Project: Heber Valley Hospital Fluoroscopy Replacement
Addendum 1

Date: August 8, 2024

From: HKS Architects, Inc
90 South 400 West, Suite 110
Salt Lake City, Utah 84101
(801) 532-2393

01 FLUOROSCOPY REMODEL PLAN
1/4" = 1'-0"

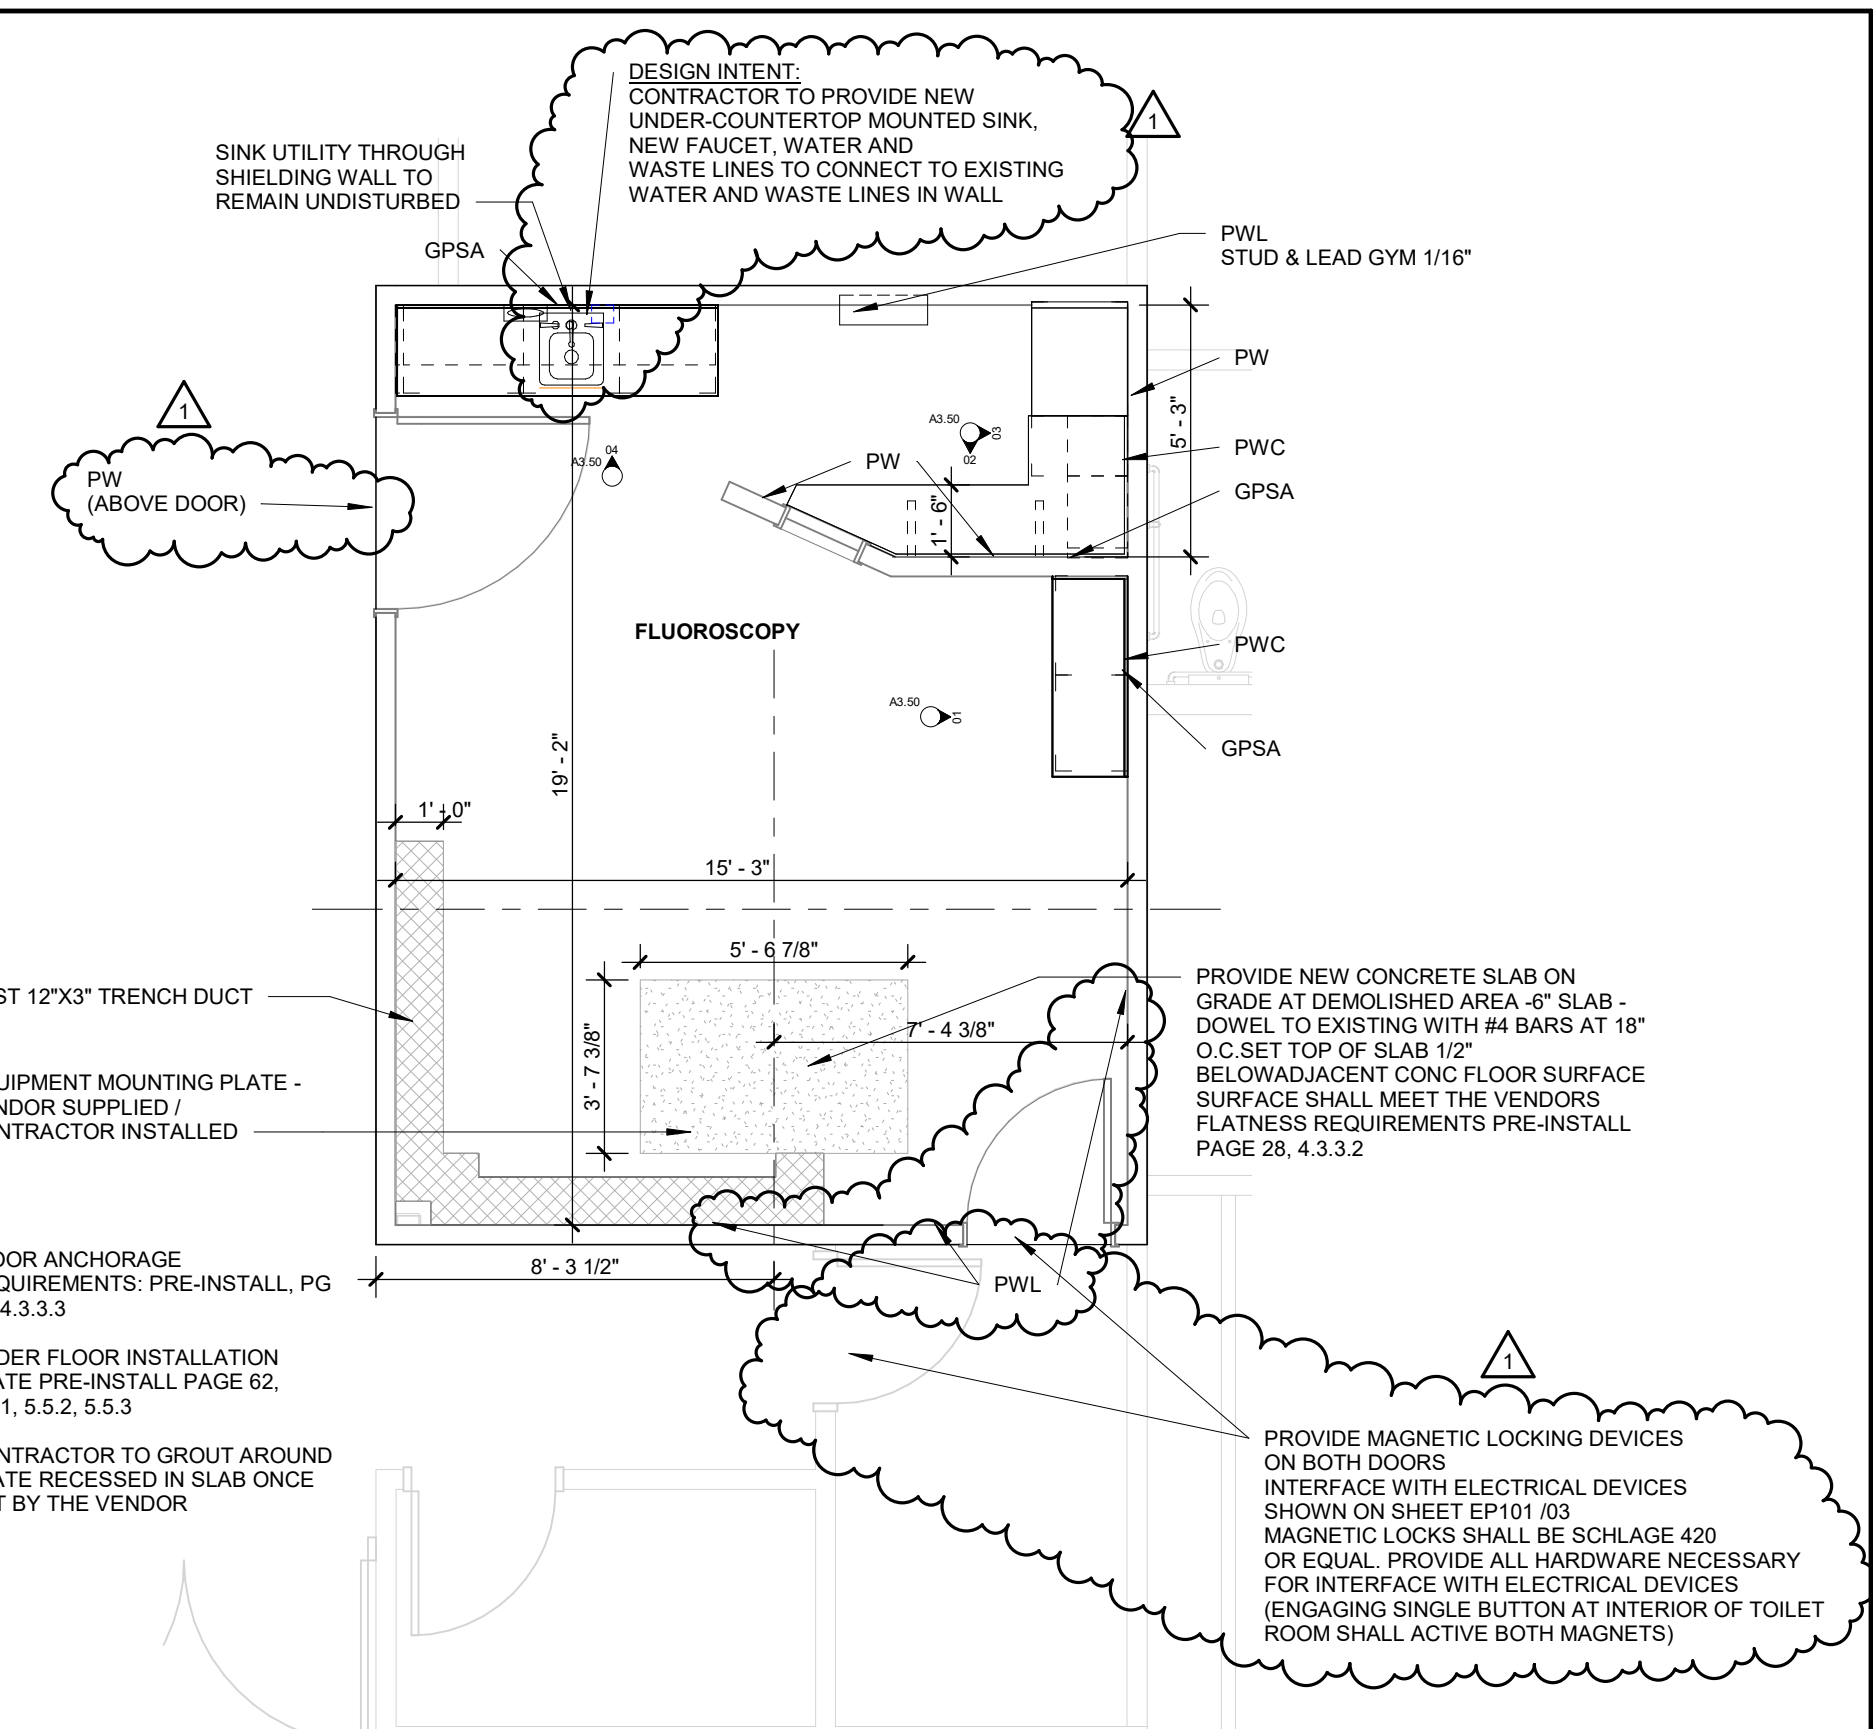
Keyed note PW in lower corner of room has been changed to PWL, with added locations

Information on sink remodel work has been added to this plan

Additional notes have been added to this plan

05 FLUOROSCOPY DEMO PLAN

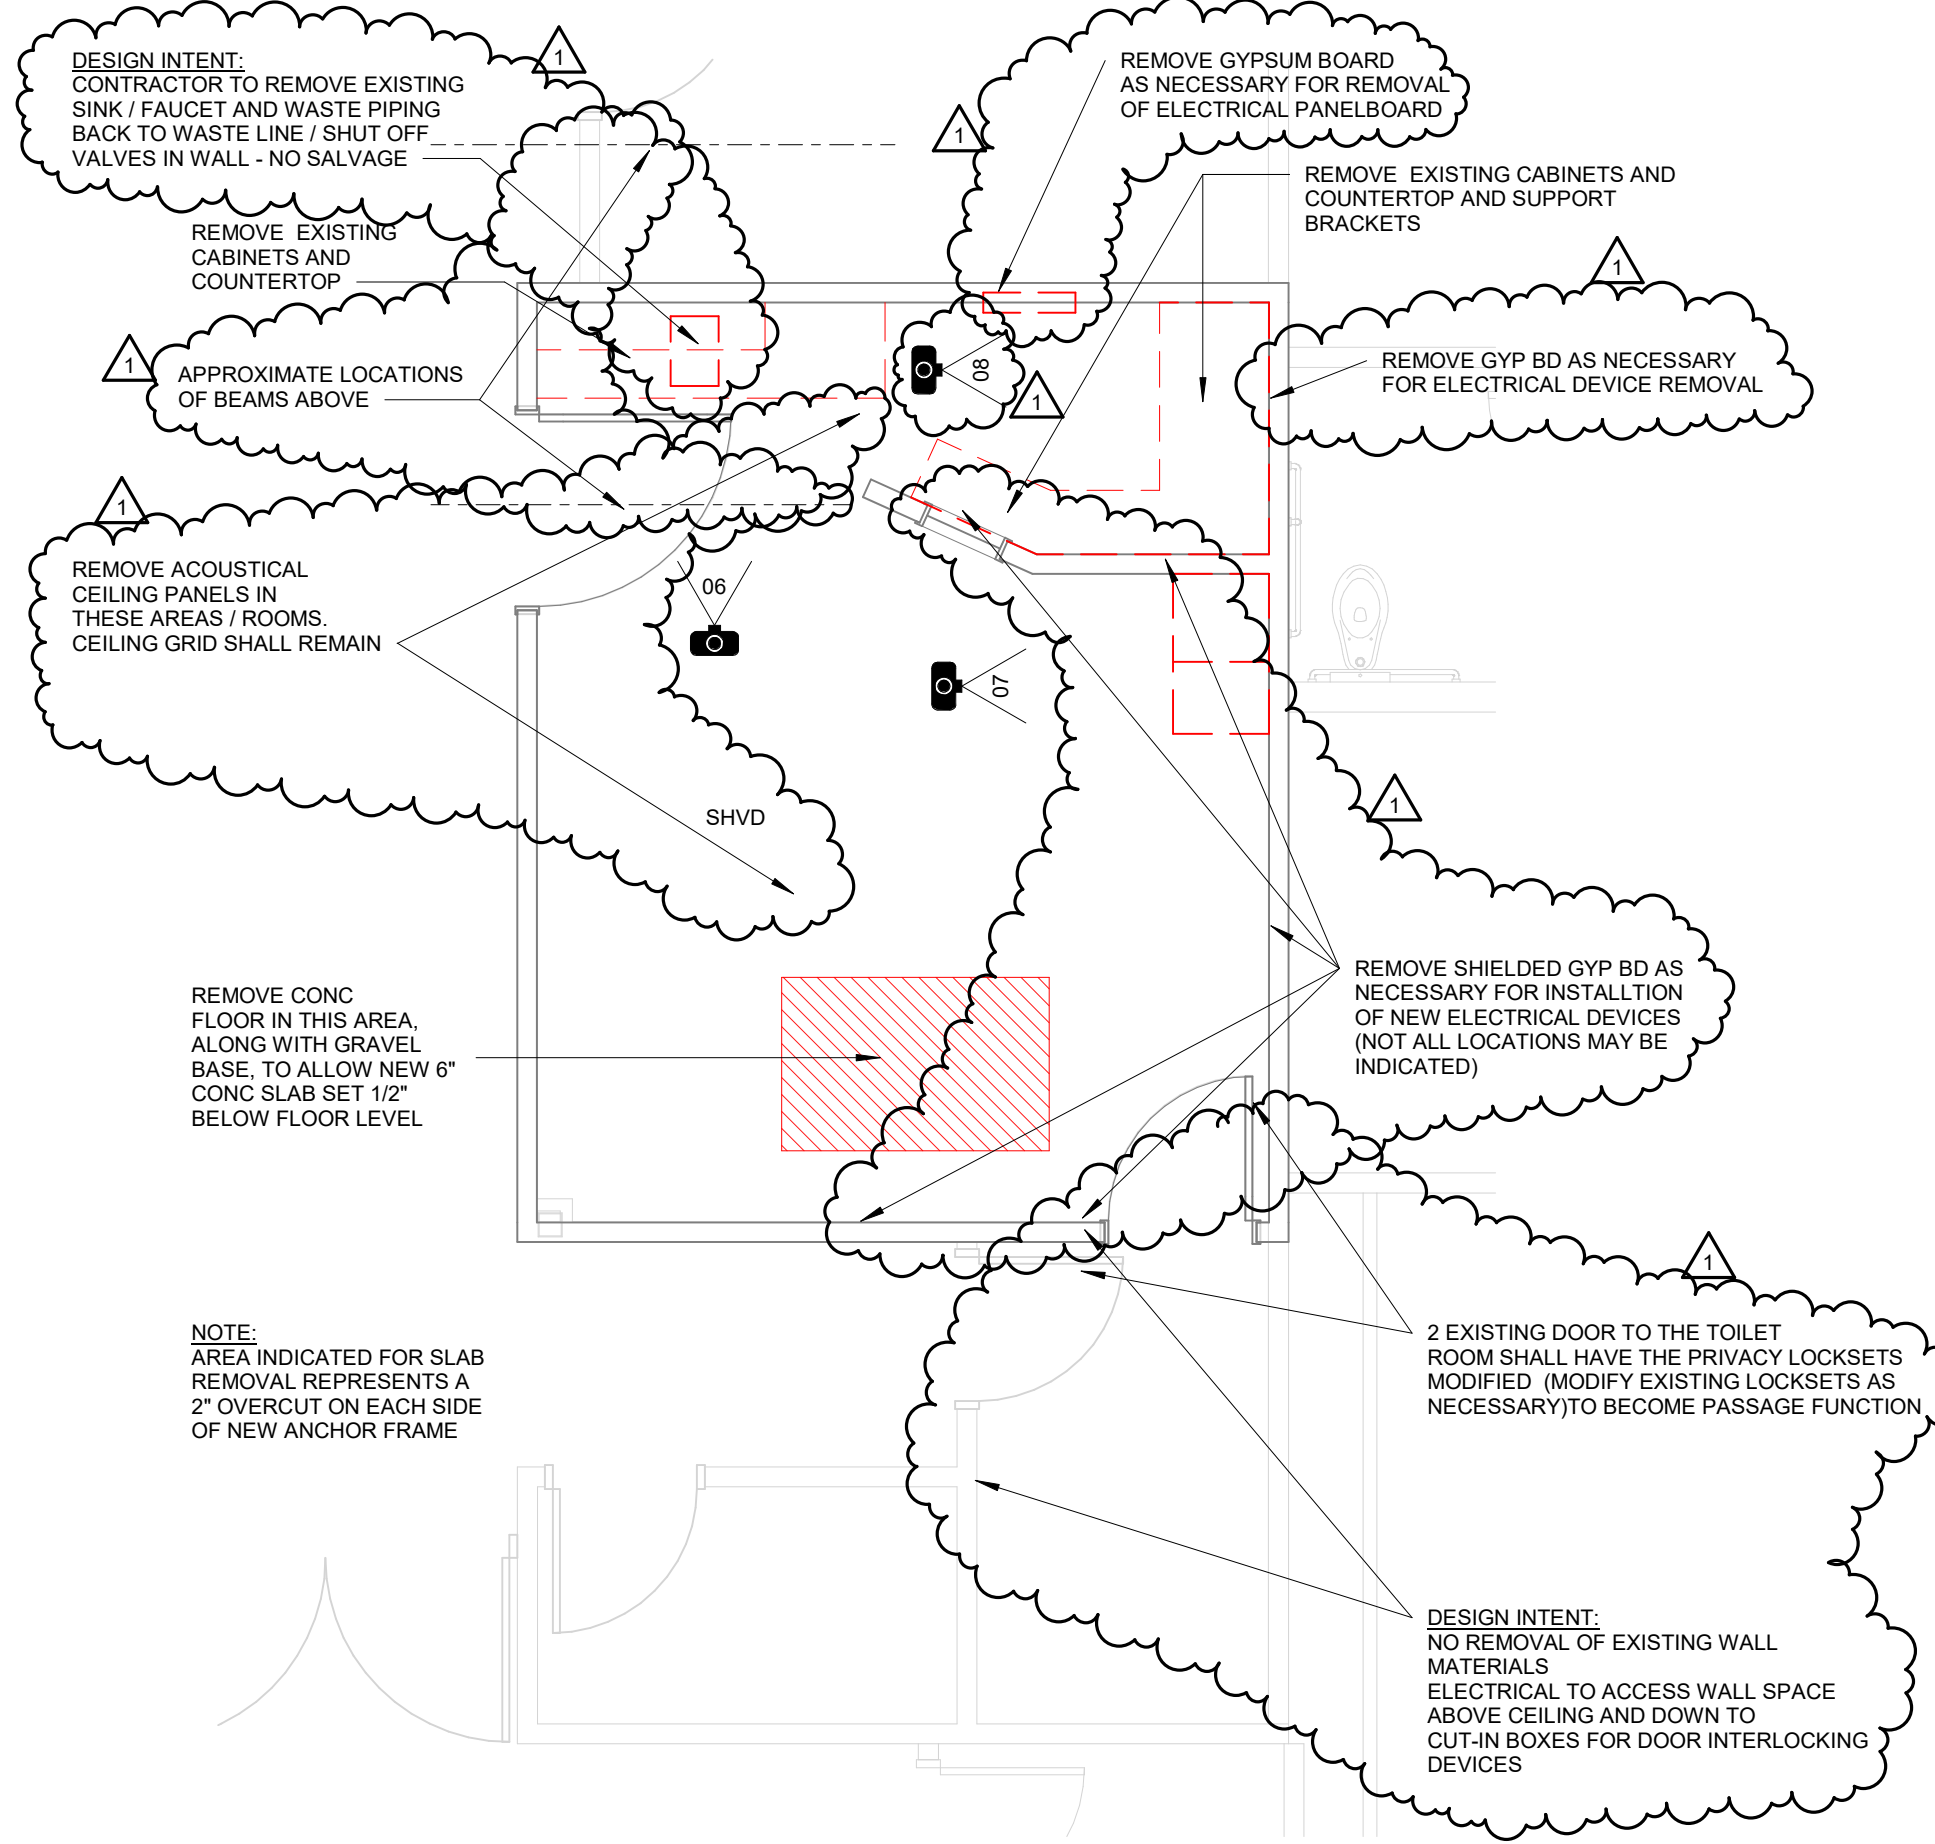
Additional notes have been added to this plan

Manual Sink Faucets 786-GN8FCXKABCP

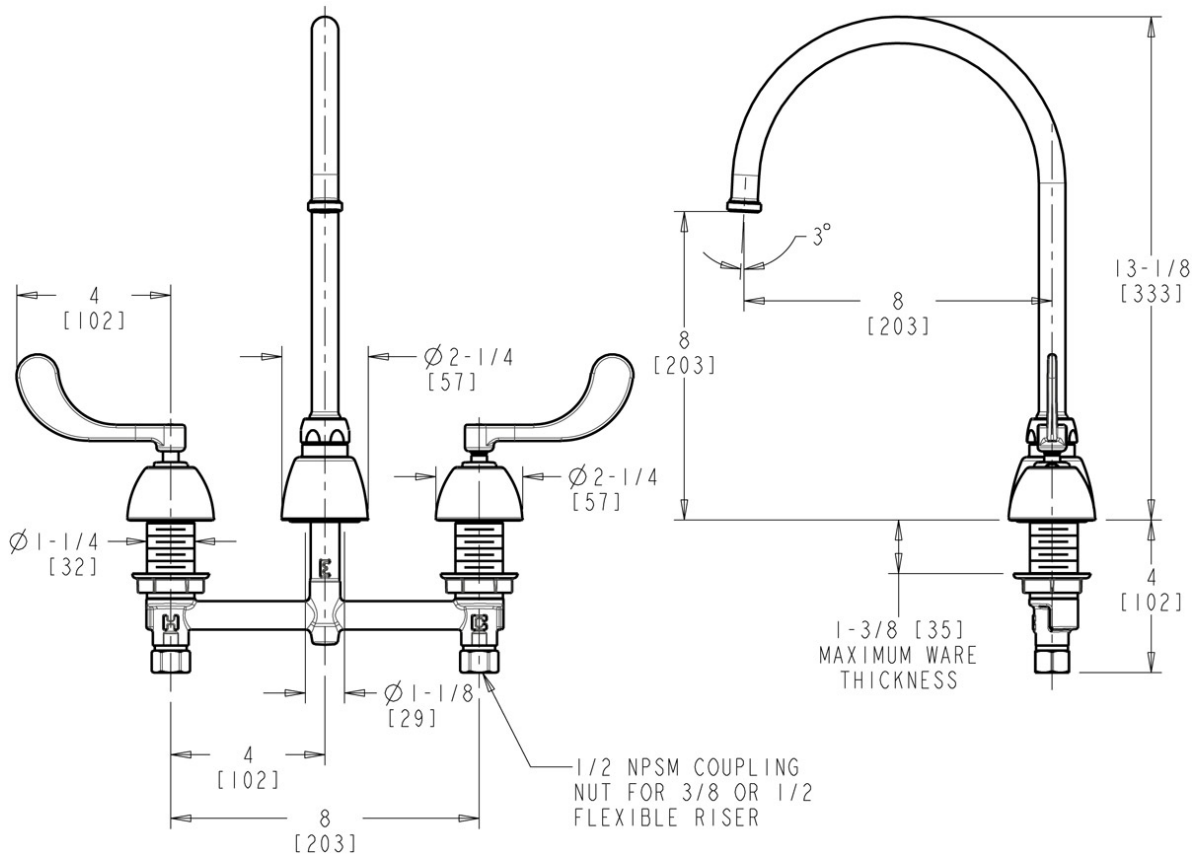
0.5 GPM LAMINATE FLOW CONTROL

PROVIDE WATTS
LFUSG-B-M2
THERMOSTATIC MIXING
VALVE WITH SLOAN
BASYS EFTT-470-A
CHECK VALVES ON HOT
AND COLD WATER

PROVIDE CHICAGO
327-XCP OPEN GRID
STRAINER AND CAST
BRASS P-TRAP WITH
CLEAN OUT PLUG
